Contract No. CV/2013/08
Liantang / Heung Yuen Wai Boundary Control Point
Site Formation and Infrastructure Works – Contract 6

Environmental Permit No. EP-404/2011/D
Condition 2.13 – Submission of Environmental Monitoring and Audit Programme (Revision 7)

Environmental Monitoring and Audit Programme (Rev.07)

Location Plan of Air Monitoring Station

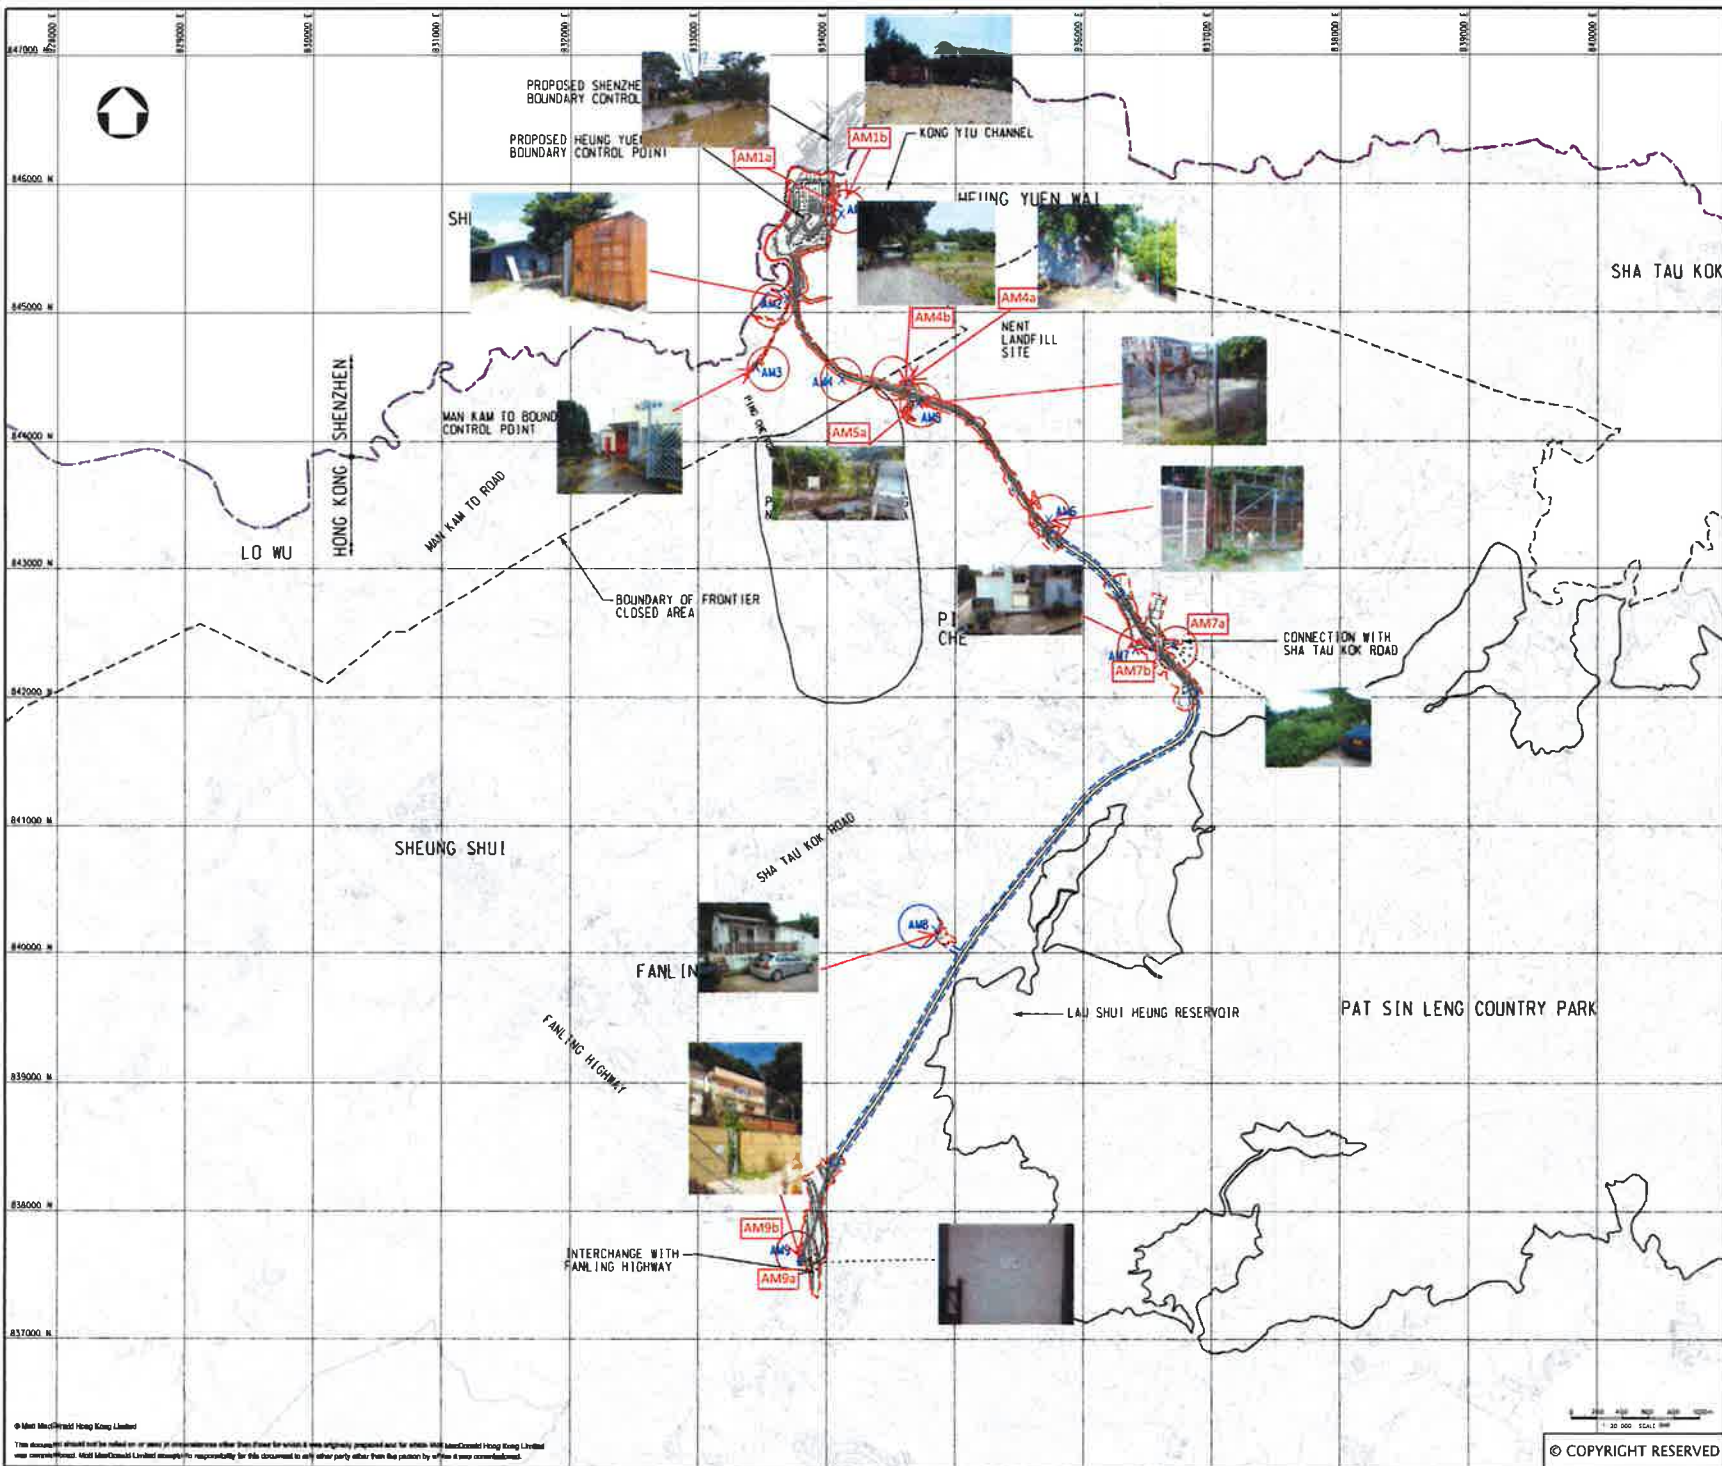
<p>Appendix A</p>	<p>The project layout plan is revised to include all contracts.</p>
<p>Appendix B</p>	<p>The location plan for air monitoring location is revised.</p>

Location Plan of Noise Monitoring Station

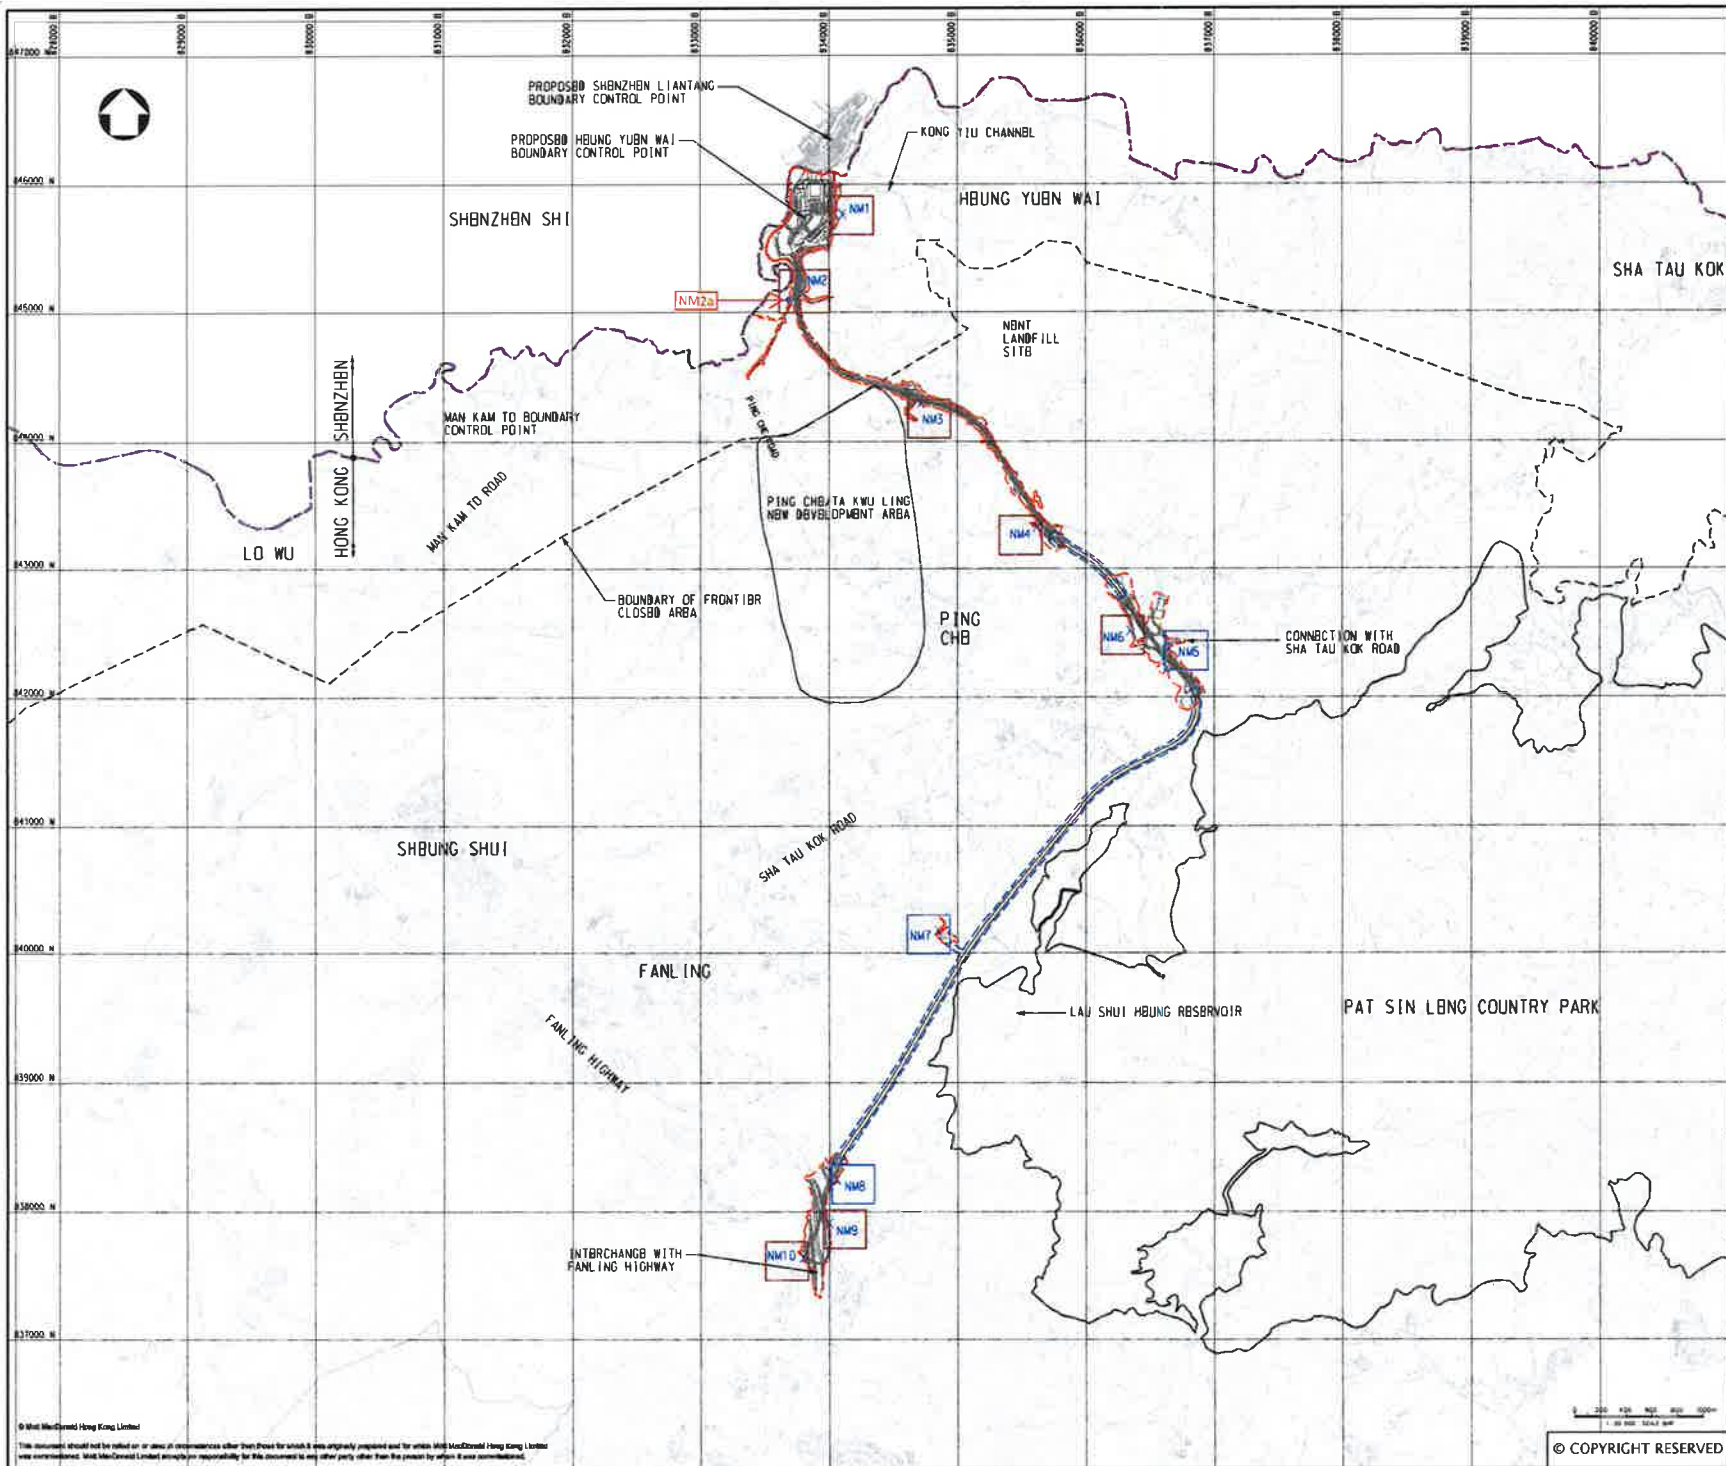
Appendix A	The Project Layout Plan is updated.
Appendix C	The location plan for noise monitoring location for Construction Phase is revised.
Appendix E	The location plan for water monitoring location is revised.
Appendix G	Proposal for amendment of Section 3.1.5 is presented in Appendix G.
Appendix H	Proposal for relocate the noise monitoring station from NM2 to NM2a is presented in Appendix H.

Figure 1. Location of map for Construction Noise Monitoring Location NM2 and NM2a

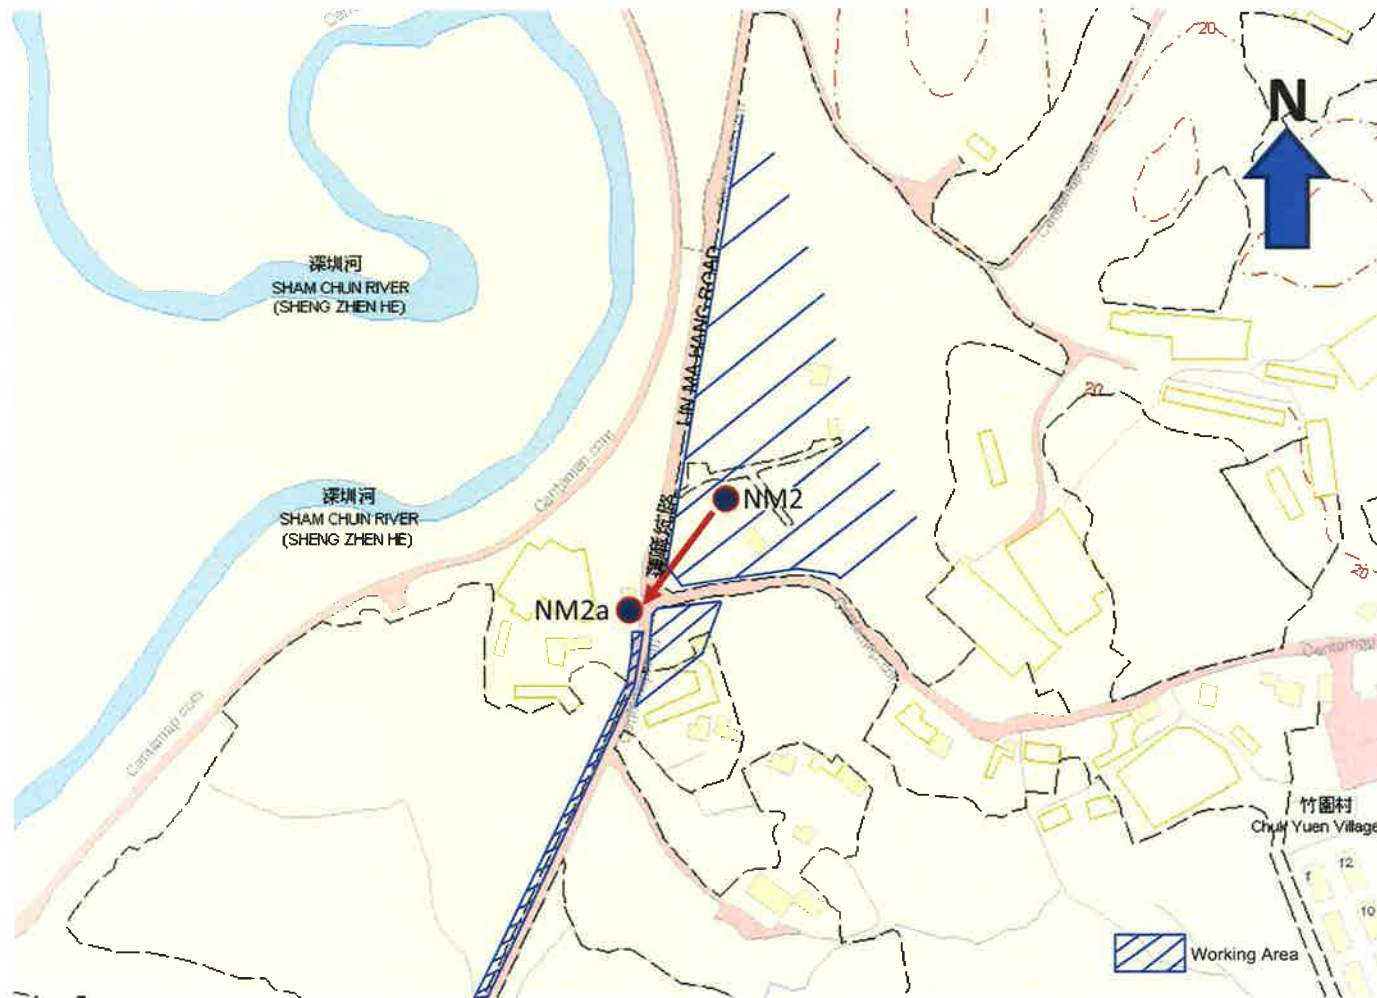
Section/ Table/ Appendix	Description
Table 3-2, page 20	Noise monitoring location NM2a was proposed to replace NM2. The proposal to relocate the noise monitoring station from NM2 to NM2a was verified by IEC and it is attached in Appendix H.
Section 3.1.5, page 21	In the 2 nd paragraph, it is considered that noise measurement during restricted hours periods is not necessary to perform. A supplementary proposal for the changes was attached in Appendix G.
Table 4.1, page 27	Water quality monitoring location WM2A(a) was proposed to replace the WM2A in May 2016. The proposal was submitted to EPD on 2 June 2016 after verify by IEC and it was approved by EPD on 27 June 2016.
Section 4.1.4, Page 30	At the last paragraph about the water depth for water quality, bullet point (c) was added to clarify that “if no suitable alternative location could be found within 15m far from the original location, the sampling at that location will be cancelled since sampling at too far from the designated location could not make a representative sample.”

Proposal for the change of noise monitoring location from NM2 to NM2a was verified by IEC and it is attached in Appendix H.
